INDESIT company

Model type:
WT6IT

Commercial code:
F026450

Notices

FIG. 1

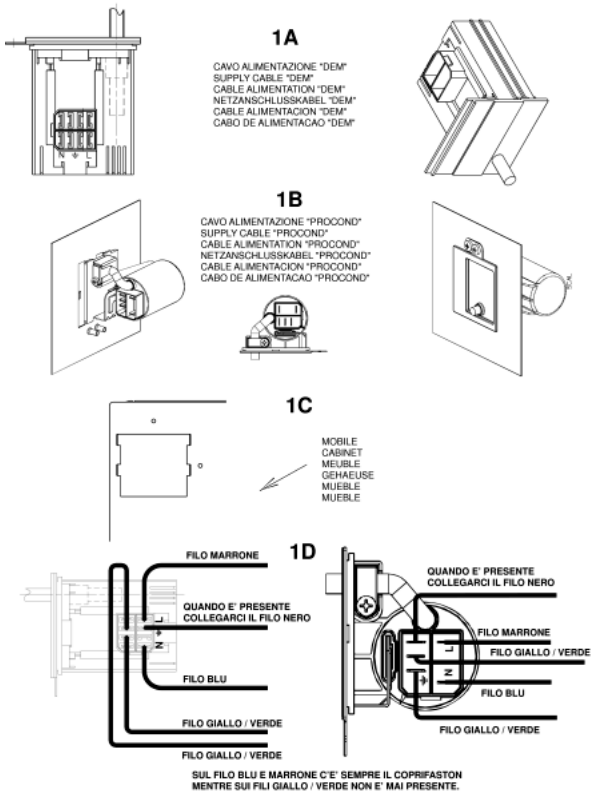
n1040288: Power supply cable + moulded filter on top-load Brembate WMs

From serial number 30224.0001, all top-load washing machines produced in the Brembate factory have been equipped with a new power supply cable with moulded filter and new rear panels with a specific opening for fixing the new cable.

To use premodified wirings on modified products perform the connection to the terminal block of the new cable as shown in fig. 1 - 1D.
The wiring diagrams indicated in the Documentation remain the same.

N1040309FIG1

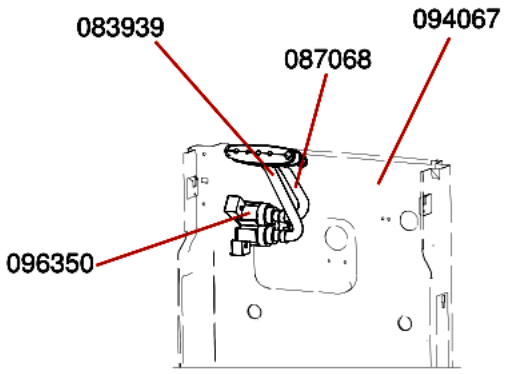
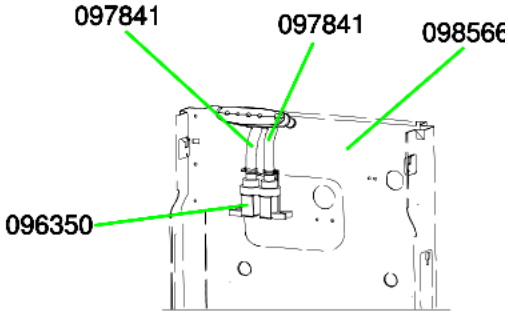
n1040309: Modification of rear panels on TOP LOADING washing machines.

From serial no. 30912.0001, the system used for fixing the loading solenoid valve (spare part code 096350) to the rear panel has been modified on Top Loading washing machines, rotating its position by 90°.
The solenoid valve (spare part code 096350) has been modified with the 45° rotation of a coil; the Replacements Warehouse will continue to manage this part with the same code. When replacing on premodification machines, fit the coils as shown in figure N1040309FIG3-1 and on modified machines, as shown in figure N1040309FIG3-2; to rotate the coil, lift it using a screwdriver and then refit according to the inserts on the plastic.

Replacement codes of the parts affected by this modification (see figure N1040309FIG1):

FIG1 A - PREMODIFICATION STRUCTURE
solenoid valve tube/distributor assembly: premodification 083939;
solenoid valve tube/distributor assembly: premodification 087068;
rear panel: premodification 094067.
FIG1 B - NEW STRUCTURE
solenoid valve tube/distributor assembly: new 097841;
solenoid valve tube/distributor assembly: new 097841;
rear panel: new 098566.

N1040309FIG2

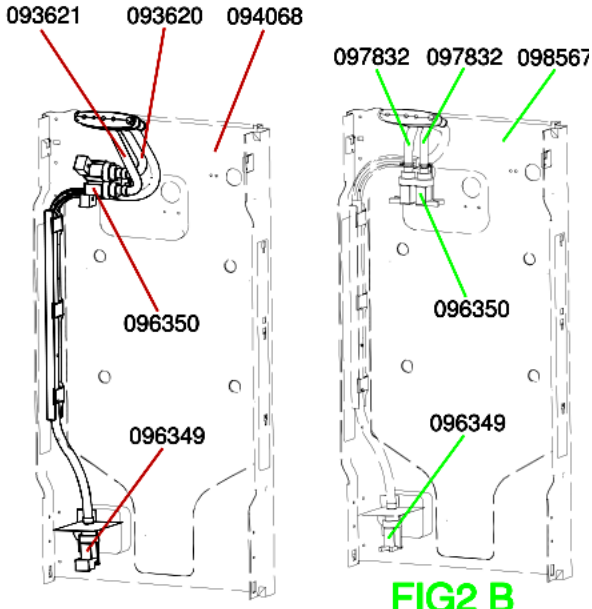
Replacement codes of the parts affected by the modification to WMTL80UK (see figure N1040309FIG2):

FIG2 A - PREMODIFICATION STRUCTURE
solenoid valve tube/distributor assembly: premodification 093620;
solenoid valve tube/distributor assembly: premodification 093621;
rear panel: premodification 094068.
FIG2 B - NEW STRUCTURE
solenoid valve tube/distributor assembly: new 097832;
solenoid valve tube/distributor assembly: new 097832;
rear panel: new 098567.

Premodification panels will be managed by the Replacements Warehouse while stocks last; when replacing with new ones on premodification appliances the new tubes must also also be used.
When using the new panels on appliances before serial no. 30609.0001, fitted with solenoid valve code 083940, rotate the coil 45° and follow the instructions given above for code 096350, paying attention during the wiring phase to keep the cables away from the bowl support spring.

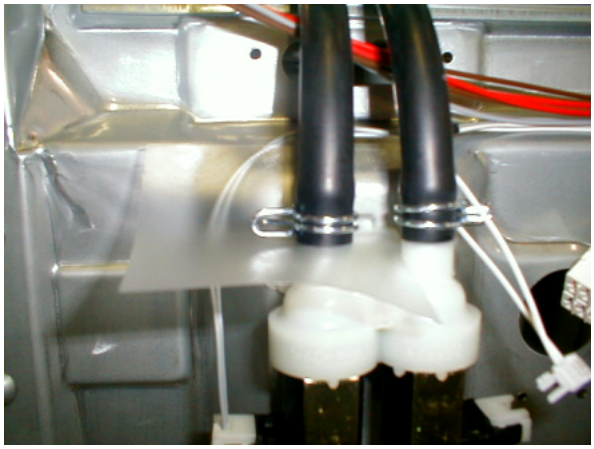
n1040321: Plastic protecion for solenoid valve.

All top-load washing machines produced from September 2003 to February 2004 (from serial no. 30900.0000 to 40300.0000)

have been equipped with a plastic protection Service code 109798 (shown in N1040321FIG1), to prevent water from damaging the solenoid valve and electronic card.

N1040324FIG1

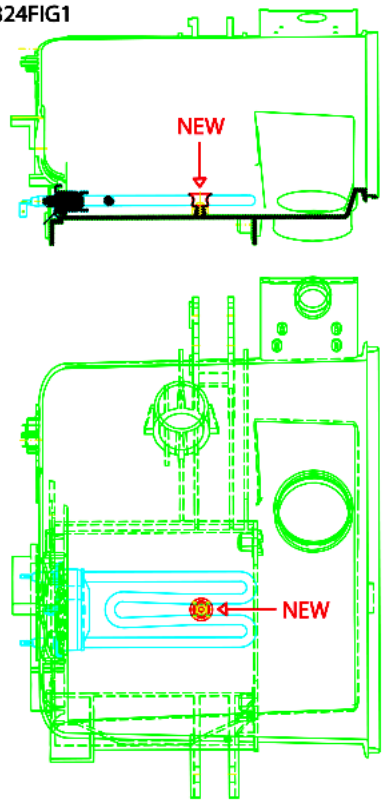
n1040324: Modification of heater fixing system on top-load washing machines.

From serial number 40506.0001, the fixing system of the heater to the tank has been modified on all top-load washing machines affected by this note, with the introduction of a metal retainer (image N1040322FIG1 reference NEW) in place of deflector Service code 055322.

The modification has involved both heater and tanks. Given below are the Service codes of the new and old items concerned:

-PLASTIC TANK FOR 600-1000 RPM MACHINES: new 110152, premodification 083805;

-PLASTIC TANK FOR 1200 RPM MACHINES: new 110153, premodification 092023;

-HEATER: new 110148, premodification 083906.

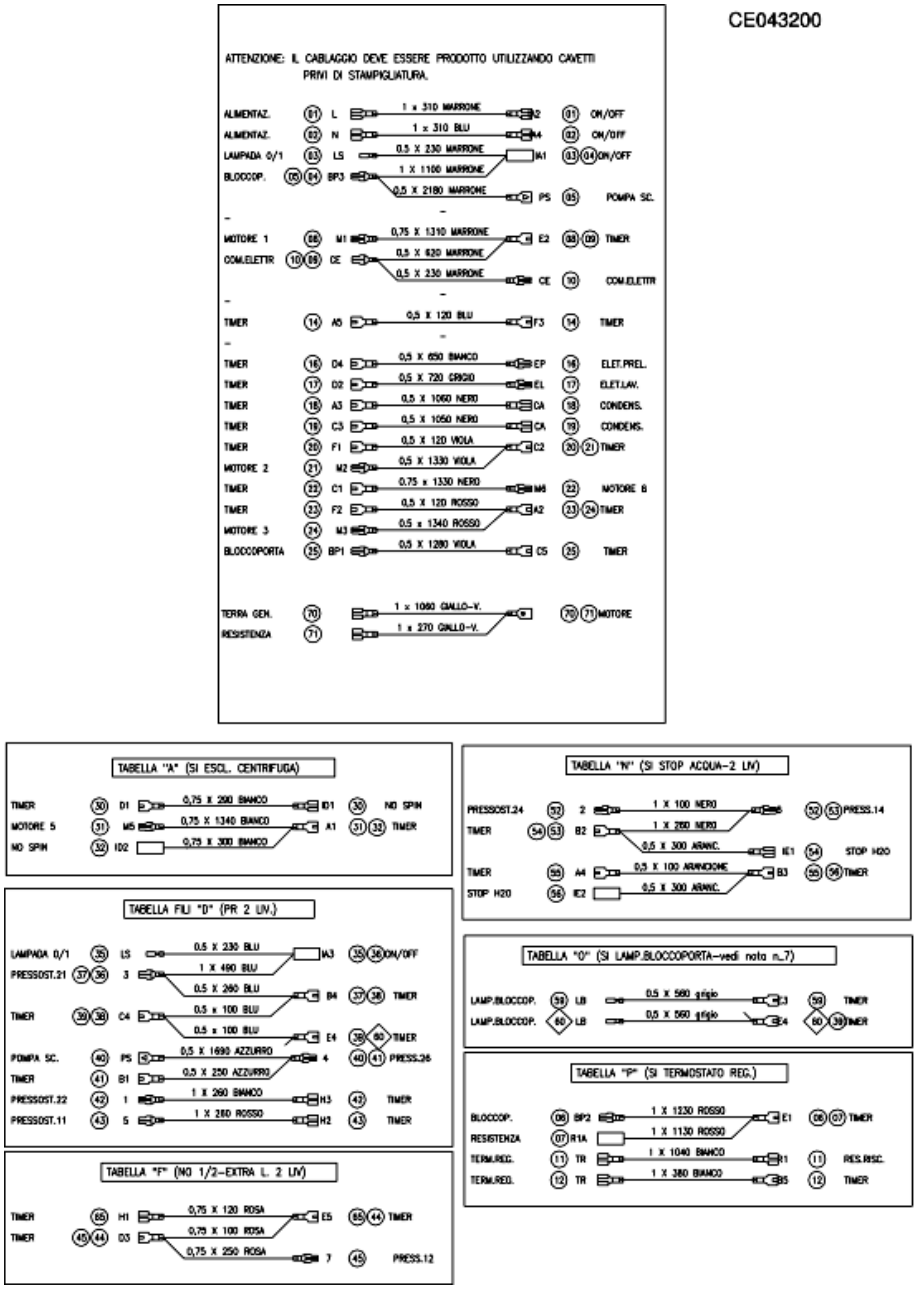
n4009a02: Motor fixing changed on Top Loading washing machines

Top Loading washing machines have changed the fix of motor to the tub.
The tub design is changed in the motor fixing side and two new screws code C00268497 are introduced instead of the old screws C00084333 and the old nut:

In assistance on premodification products with the new tubs, you have to fix the motor using the new screws C00268497 instead of the screws and nut that you find in the product.

s/n 80818.0001 - all models 1400 rpm Collector and Triphase motor

s/n 80818.0001 - all models 600 – 800 – 1000 – 1200 rpm Triphase motor

s/n 90113.0001 - all models 600 – 800 – 1000 – 1200 rpm Collector motor
